UNITED STATES PATENT AND TRADEMARK OFFICE

APPLICATION NO.	FILING DATE	FIRST NAMED INVENTOR	ATTORNEY DOCKET NO.	CONFIRMATION NO.
10/728,892	12/08/2003	Jun-Won Kang	1568.1080	9667
49455 7590 01/24/2008 STEIN, MCEWEN & BUI, LLP 1400 EYE STREET, NW SUITE 300 WASHINGTON, DC 20005			EXAMINER LAIOS, MARIA J	
			ART UNIT 1795	PAPER NUMBER
			MAIL DATE 01/24/2008	DELIVERY MODE PAPER

Office Action Summary

DETAILED ACTION

FIG. 28

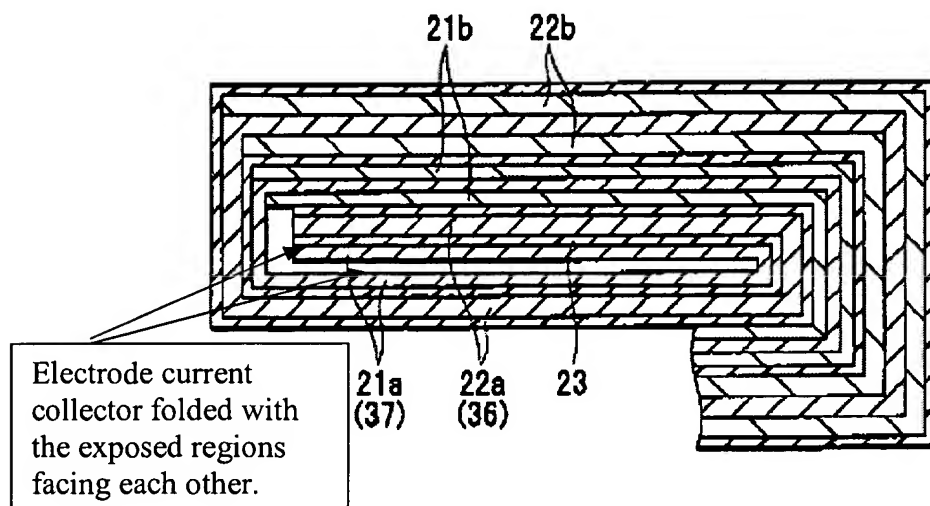
With respect to claims 5 and 12, Shibamoto further discloses the current collector (21a) is folded in upon itself such that any burrs that occurred from the manufacturing process will come in contact with the same material (Figure 28).

With respect to claims 21-24, Shibamoto discloses the folded portion is provided on the cathode where the uncoated portions are formed on both sides (37, double sided exposed portion) of the electrode plate and the exposed portions face each other (as seen in Figure 28 above).
